### Addendum Number 02

Project	Ramsey - Baske	etball Locker Roon	n	Dat	e 11/3	30/2021
Project Location	92 Catamount F Cullowhee, NC 2			Arc	nitect's P	roject Number 09.9478.000
Owner / Client	Western Carolin	a University		File	A2	This is page 1 of 2
То	Western Carolin	a University, Faci	lities Management	Atte	ention	Daniel Fiskeaux
Address	3476 Old Cullov	vhee Road				
City	Cullowhee			Stat	e NC	Zip 28723 Code
Delivered via:	🗌 Me	ssenger 🗌	Hand carried	☐ Facsim	ile	
	🗌 Exp	oress 🗌	Pick-up	🛛 E-mail	Address	
	🗌 Ma	ii 🗆	UPS	🗌 Websit	e Addres	S
any of the Work of all re Addendum supersede of	levant contents of thi nly those conflicting is	s Addendum. In case o sues. It is the respons	of conflicting provisions vibility of the Contractor	with previous a to notify all su	addenda o Ibcontract	nd all others performing or supplying or communications, provisions in this fors from whom it accepts bids of all Idendum number and its date in the

Addendum 02 forms a part of the Contract Documents for the above referenced project. The following specifications are revised to capture the questions in RFI1. The following drawings are added and revised to capture the questions in RFI1, updated door f

Project Name **RAMSEY - BASKETBALL** LOCKER ROOM RENOVATION Project Number 009.9478.000 Description INTERIOR ELEVATIONS @ SHOWERS Scale 1/2" = 1'-0" 11.110

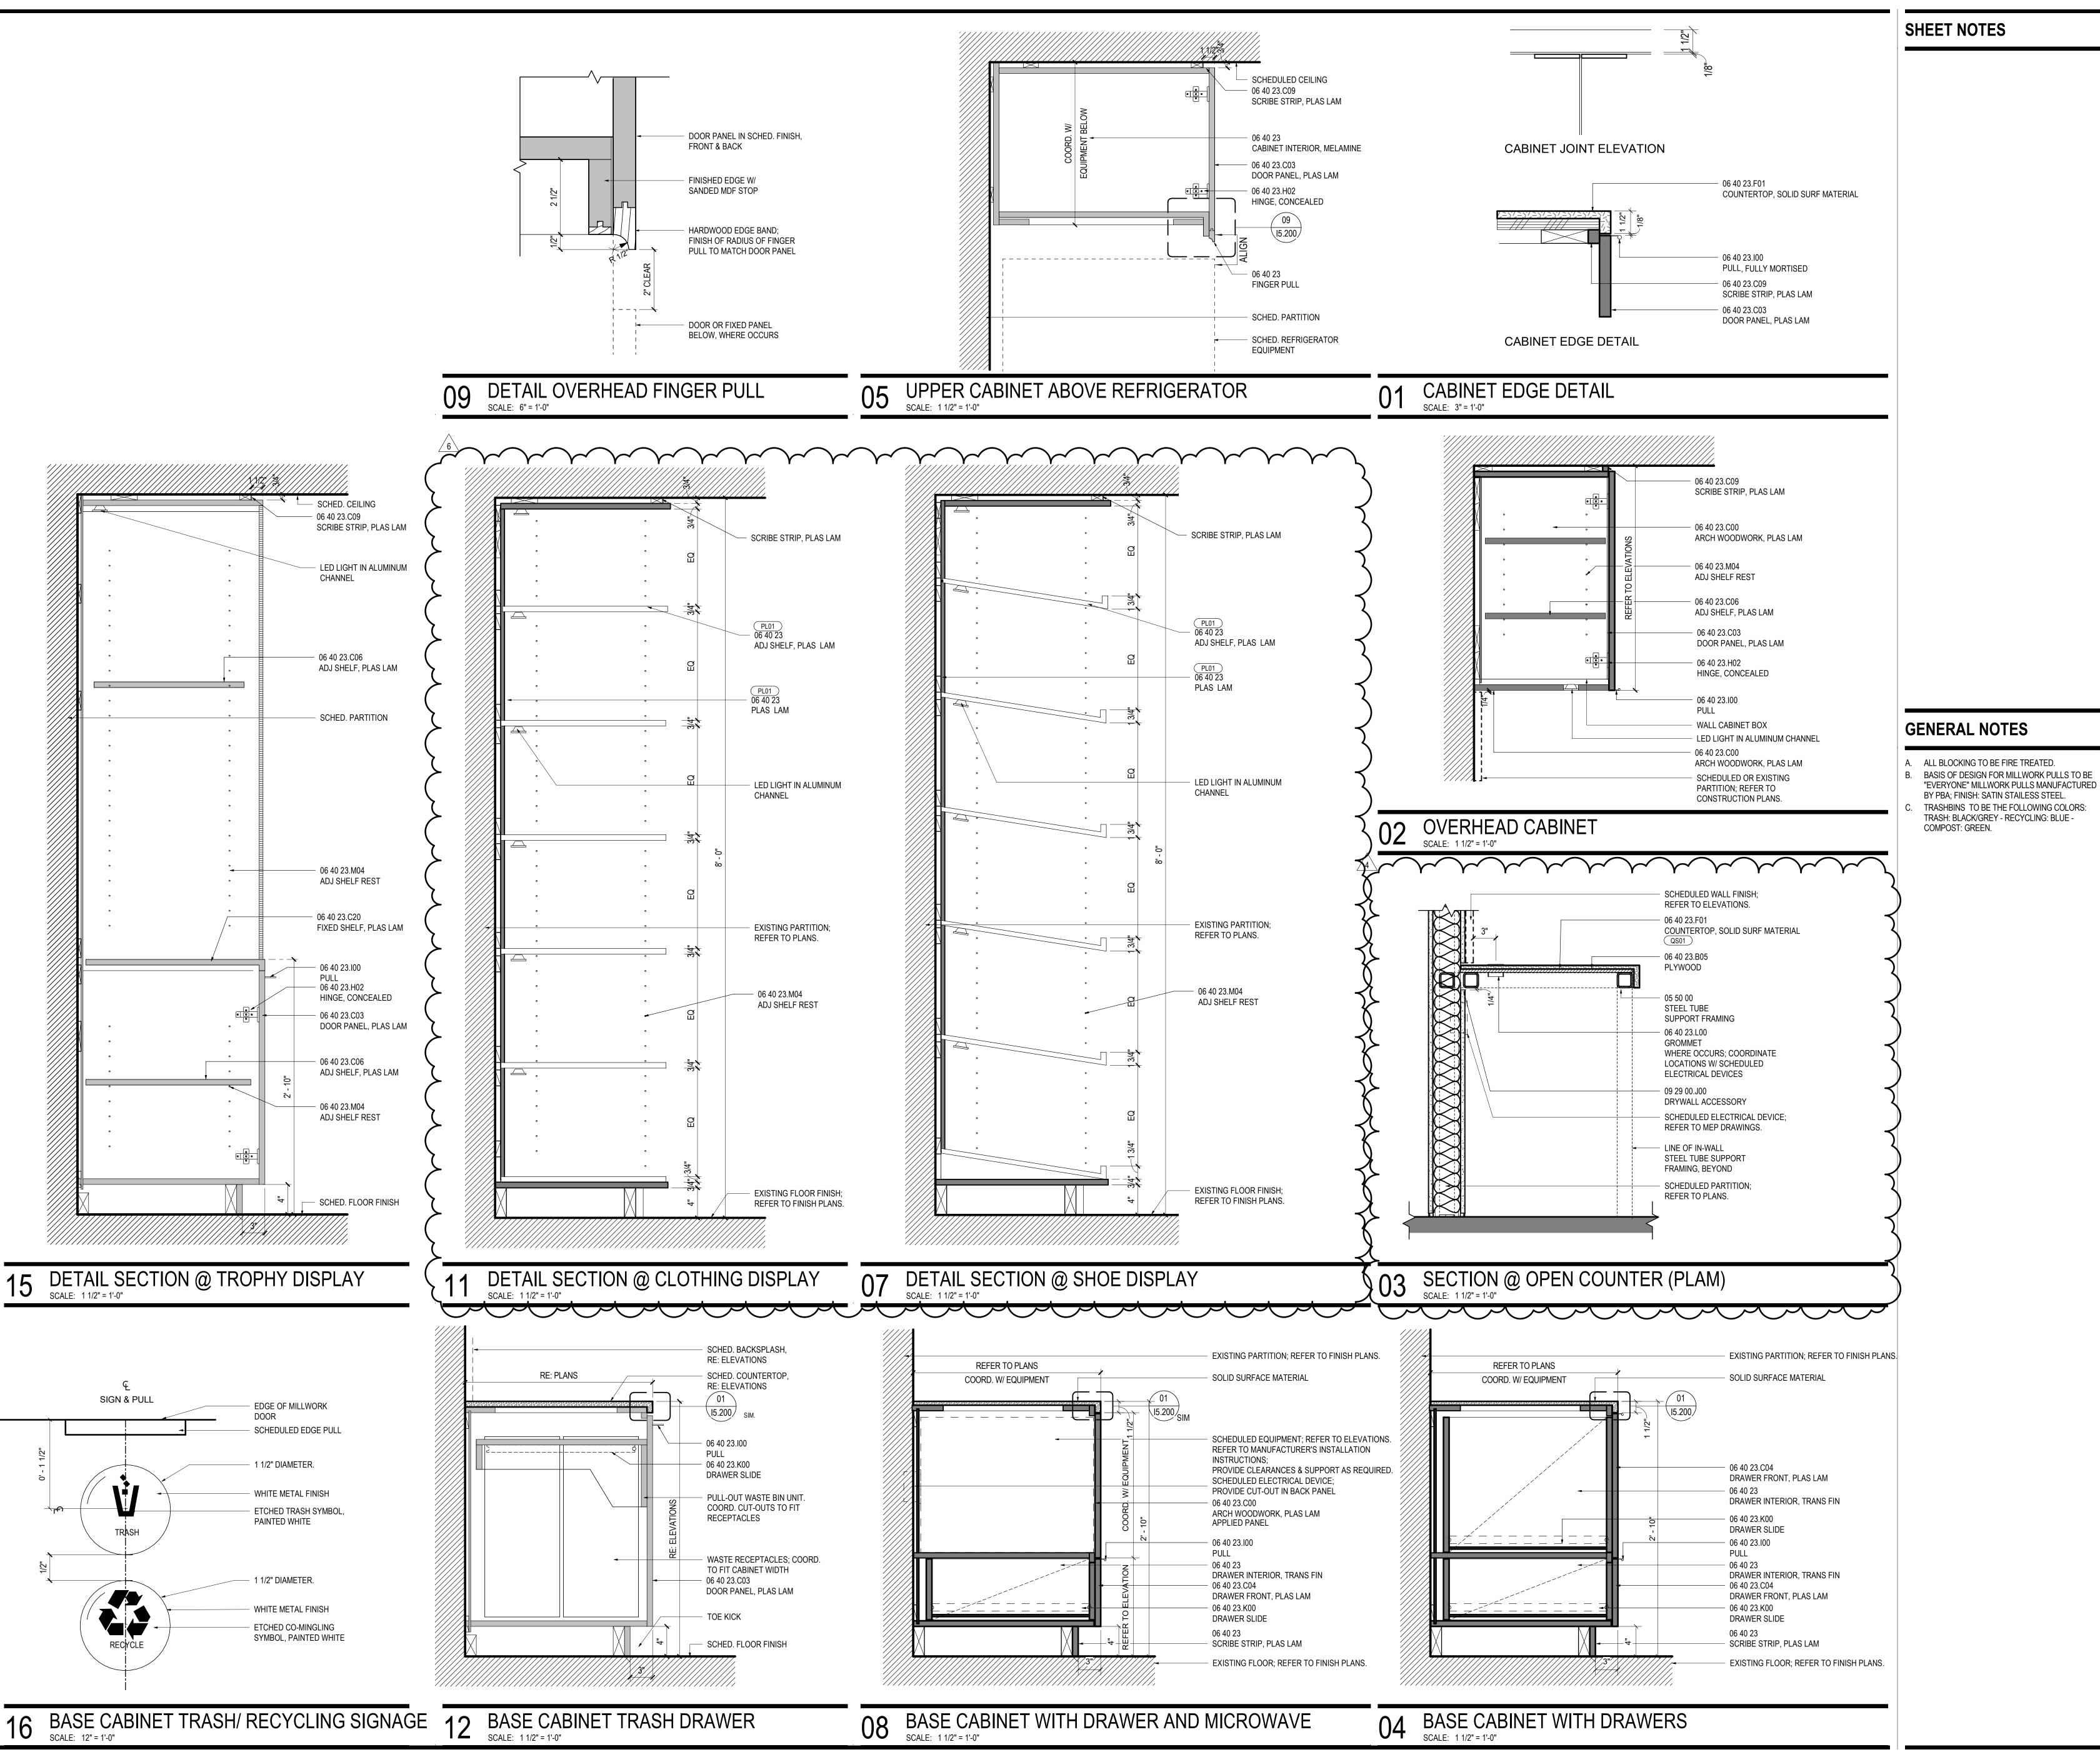
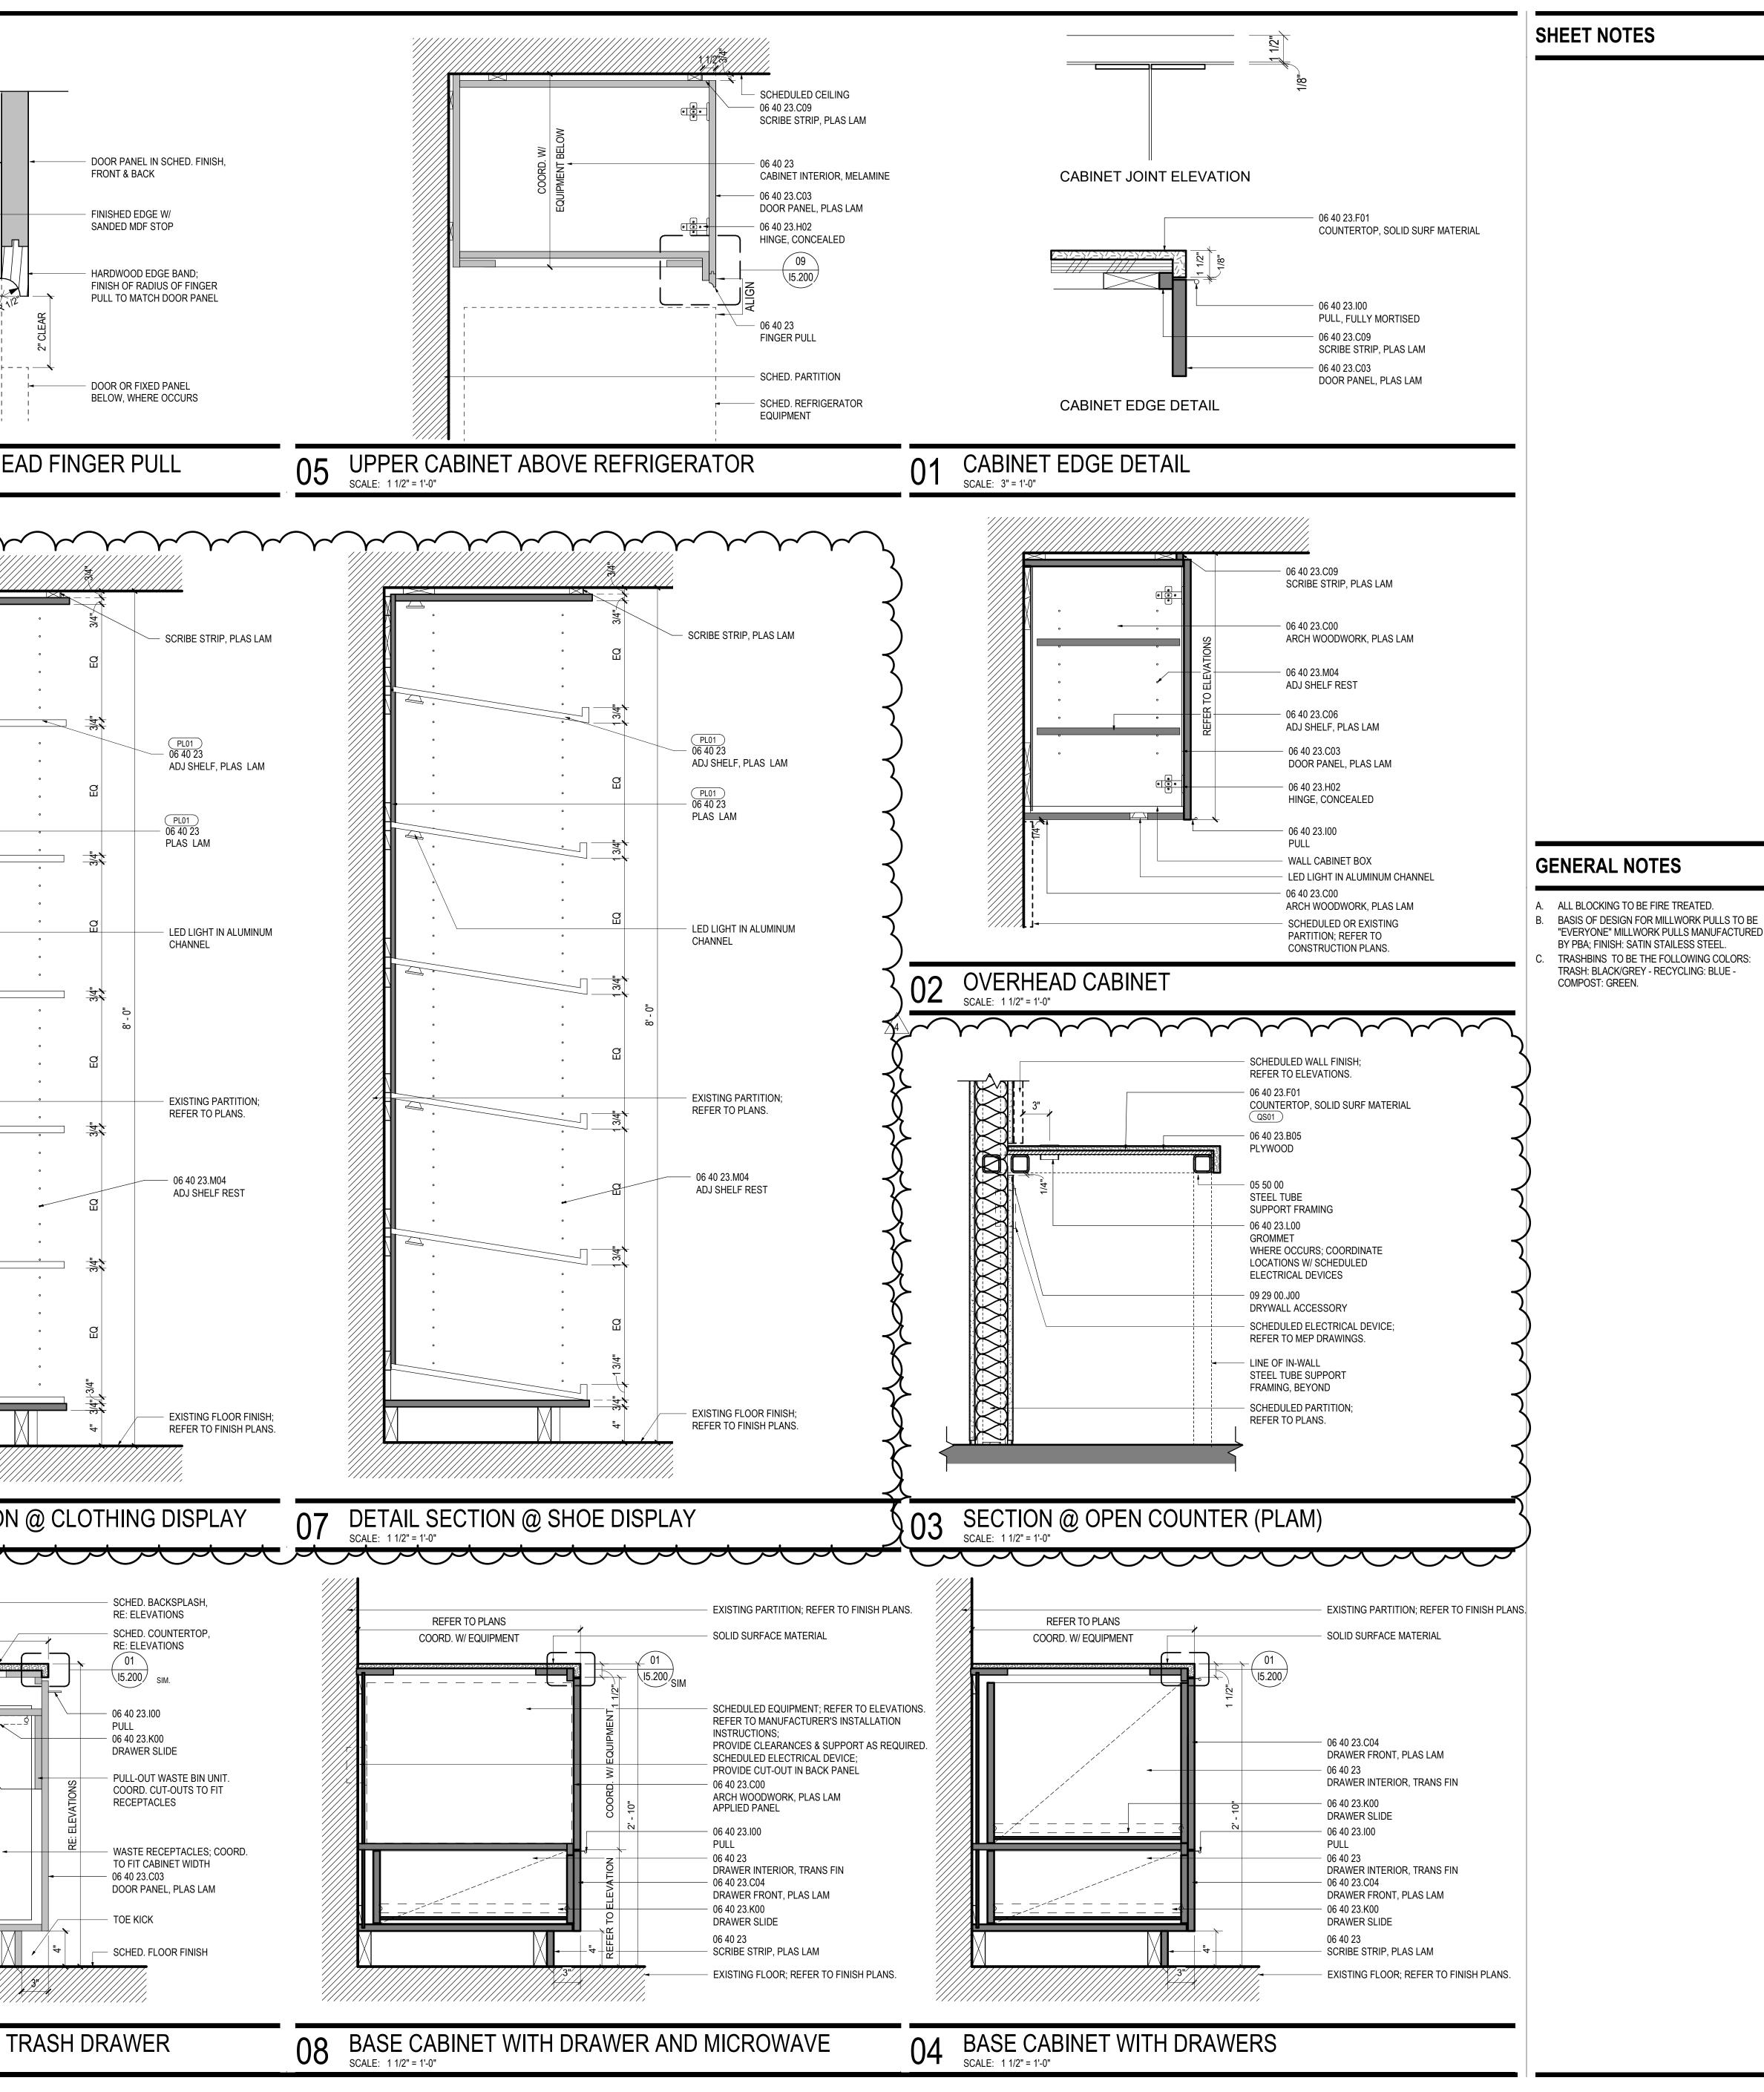
33	11/24/2021	Brantley Construction Company	Is the wall tile in Shower Rooms 1423 & 1423A full height, floor to ceiling?	The wall tile in Shower Rooms 1423 & 1423A are full height, floor to ceiling. Refer to Sheet I1.110.	Gensler	11/30/2021	AD02
34	11/24/2021	Brantley Construction Company	Are locker rooms considered "wet areas" requiring moisture resistant gypsum board per note 15 on A1.000?	Yes locker rooms are considered "wet areas" and require moisture resistant gypsum board.	Gensler	11/30/2021	AD02
